RE: REVISED DRAINAGE REPORT FOR RICHFIELD SUBDIVISION
(D-20/D3G) (REVISED PAD SIZE) UPDATE DATED 10/91
RECEIVED OCTOBER 24, 1991

SUBJECT: Richfield Subdivision (formerly Heritage East Unit 7), Albuquerque, New Mexico - DRB No. 87-363, DRC No. 3464

RE: FINAL GRADING & EROSION CONTROL PLAN SUBMITTAL OF HERITAGE EAST, UNIT 7, RECEIVED AUGUST 11, 1987 FOR WORK ORDER AND FINAL PLAT APPROVAL (D-20/D3G)

RE: DRAINAGE REPORT SUBMITTAL OF HERITAGE EAST, UNIT 7 SUBDIVISION RECEIVED JUNE 15, 1987 FOR PRELIMINARY PLAT APPROVAL (D-20/D3G)

PALOMAS
ROSA
ALLANDE
Need for Volumes

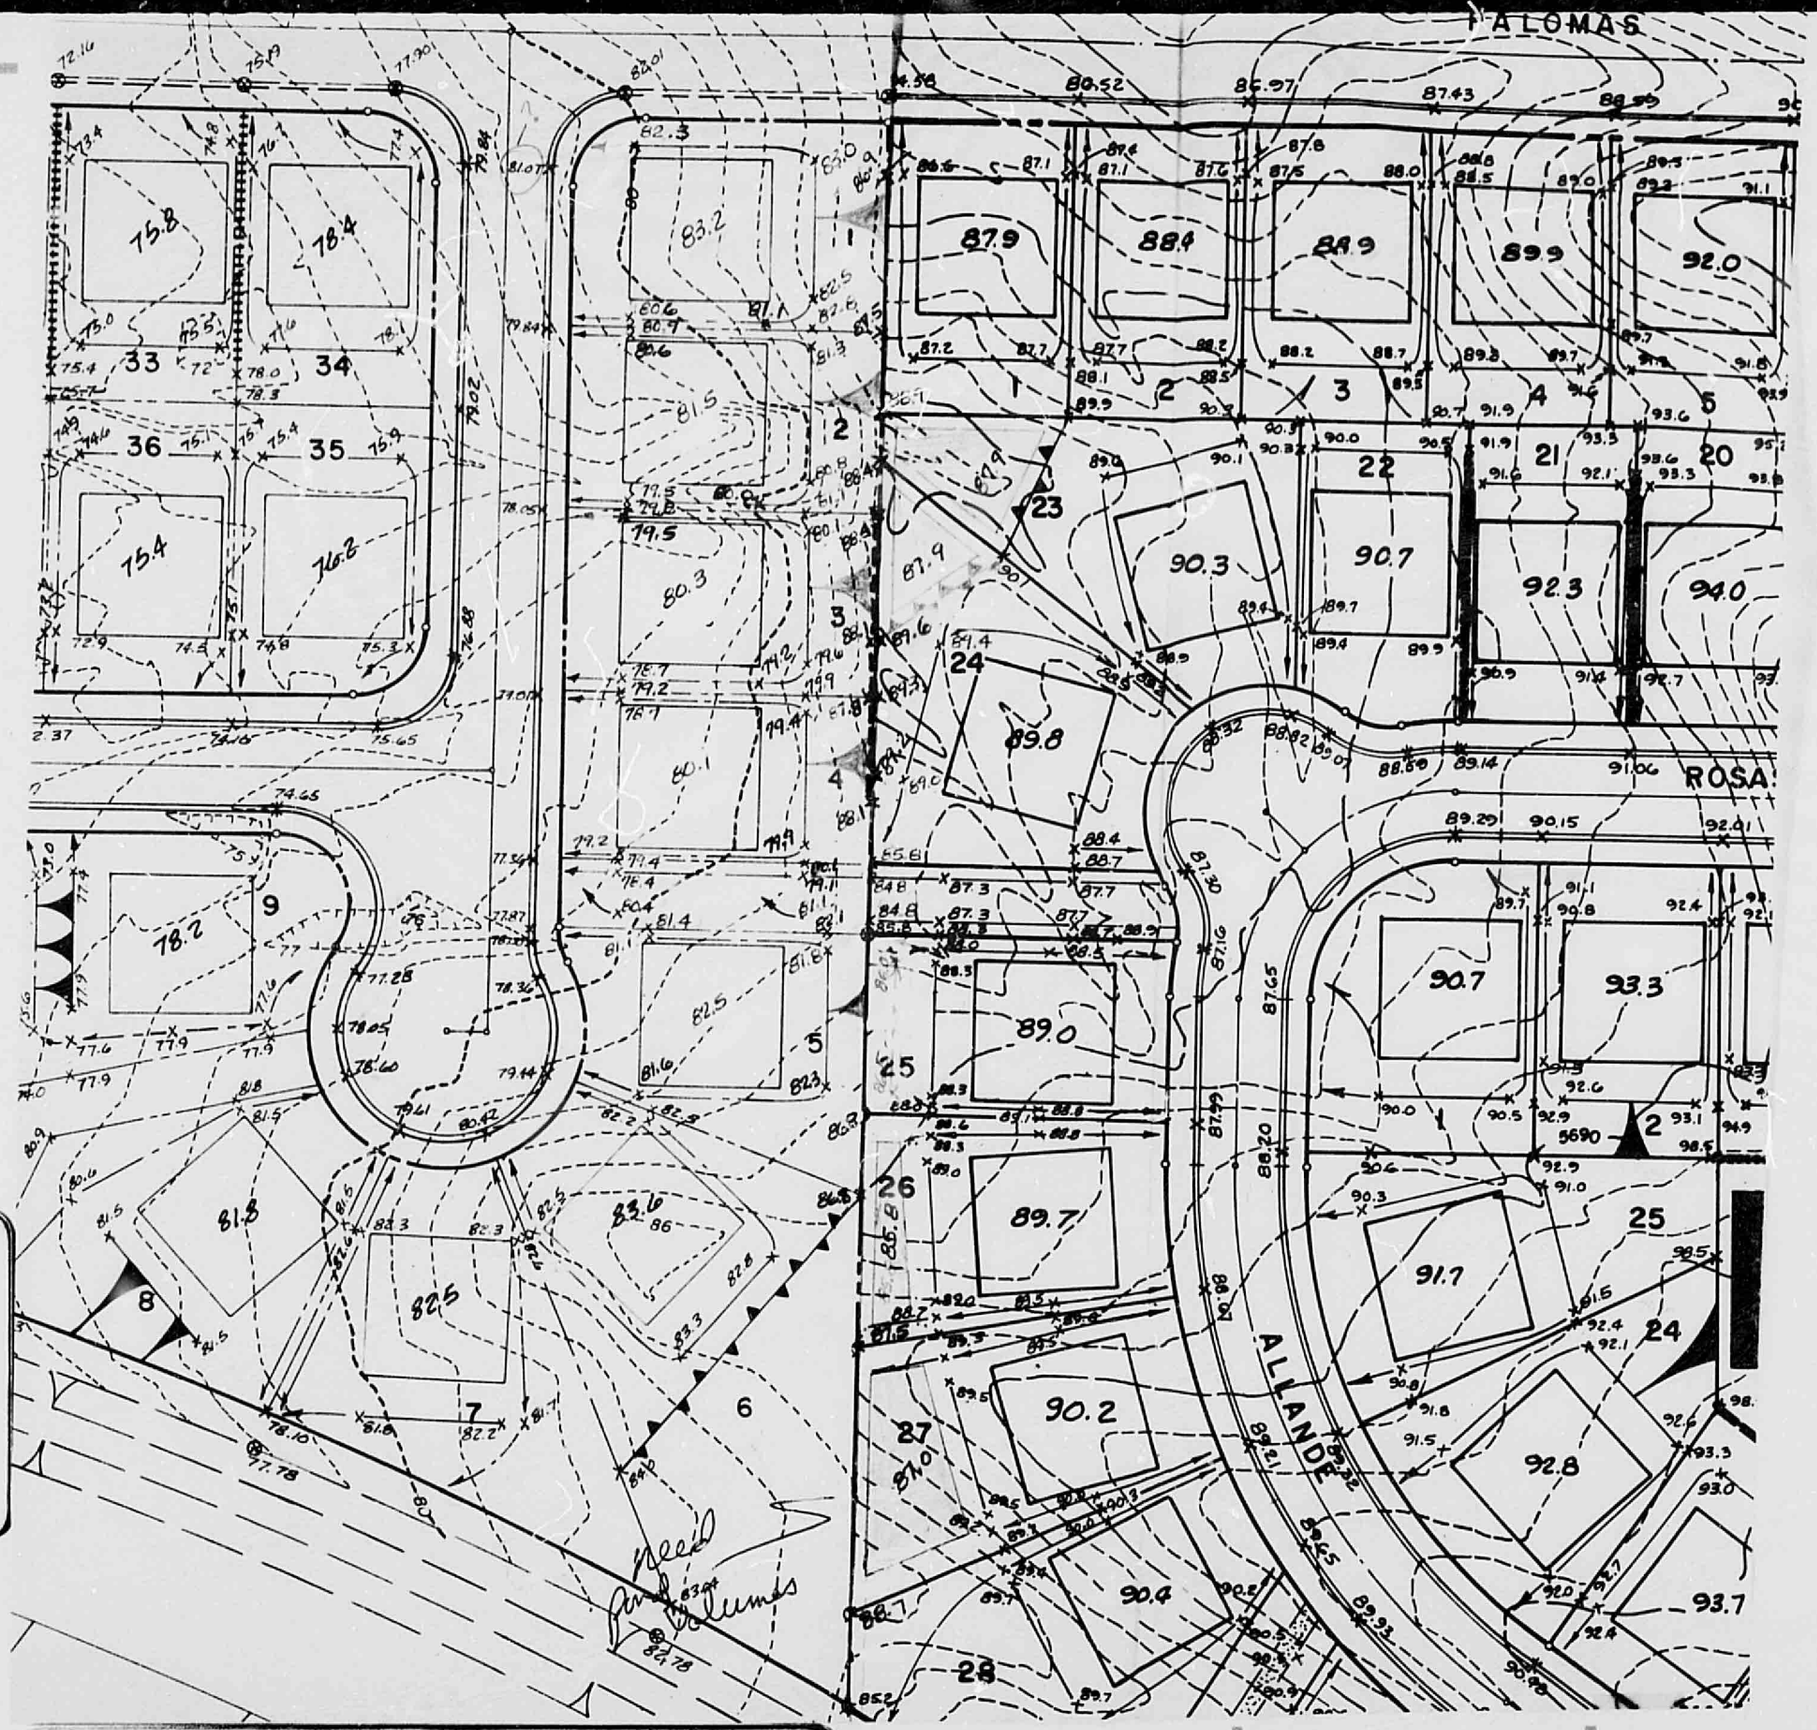
Please find attached a proposed revision to the grading plan for Heritage East, Units 6 and 7. We are suggesting this change to avoid cross-lot drainage (and the required private drainage easements).

7/17/87
No Objection. Make required submittals.
(Talked to Mike Yost by phone)
RAGreen
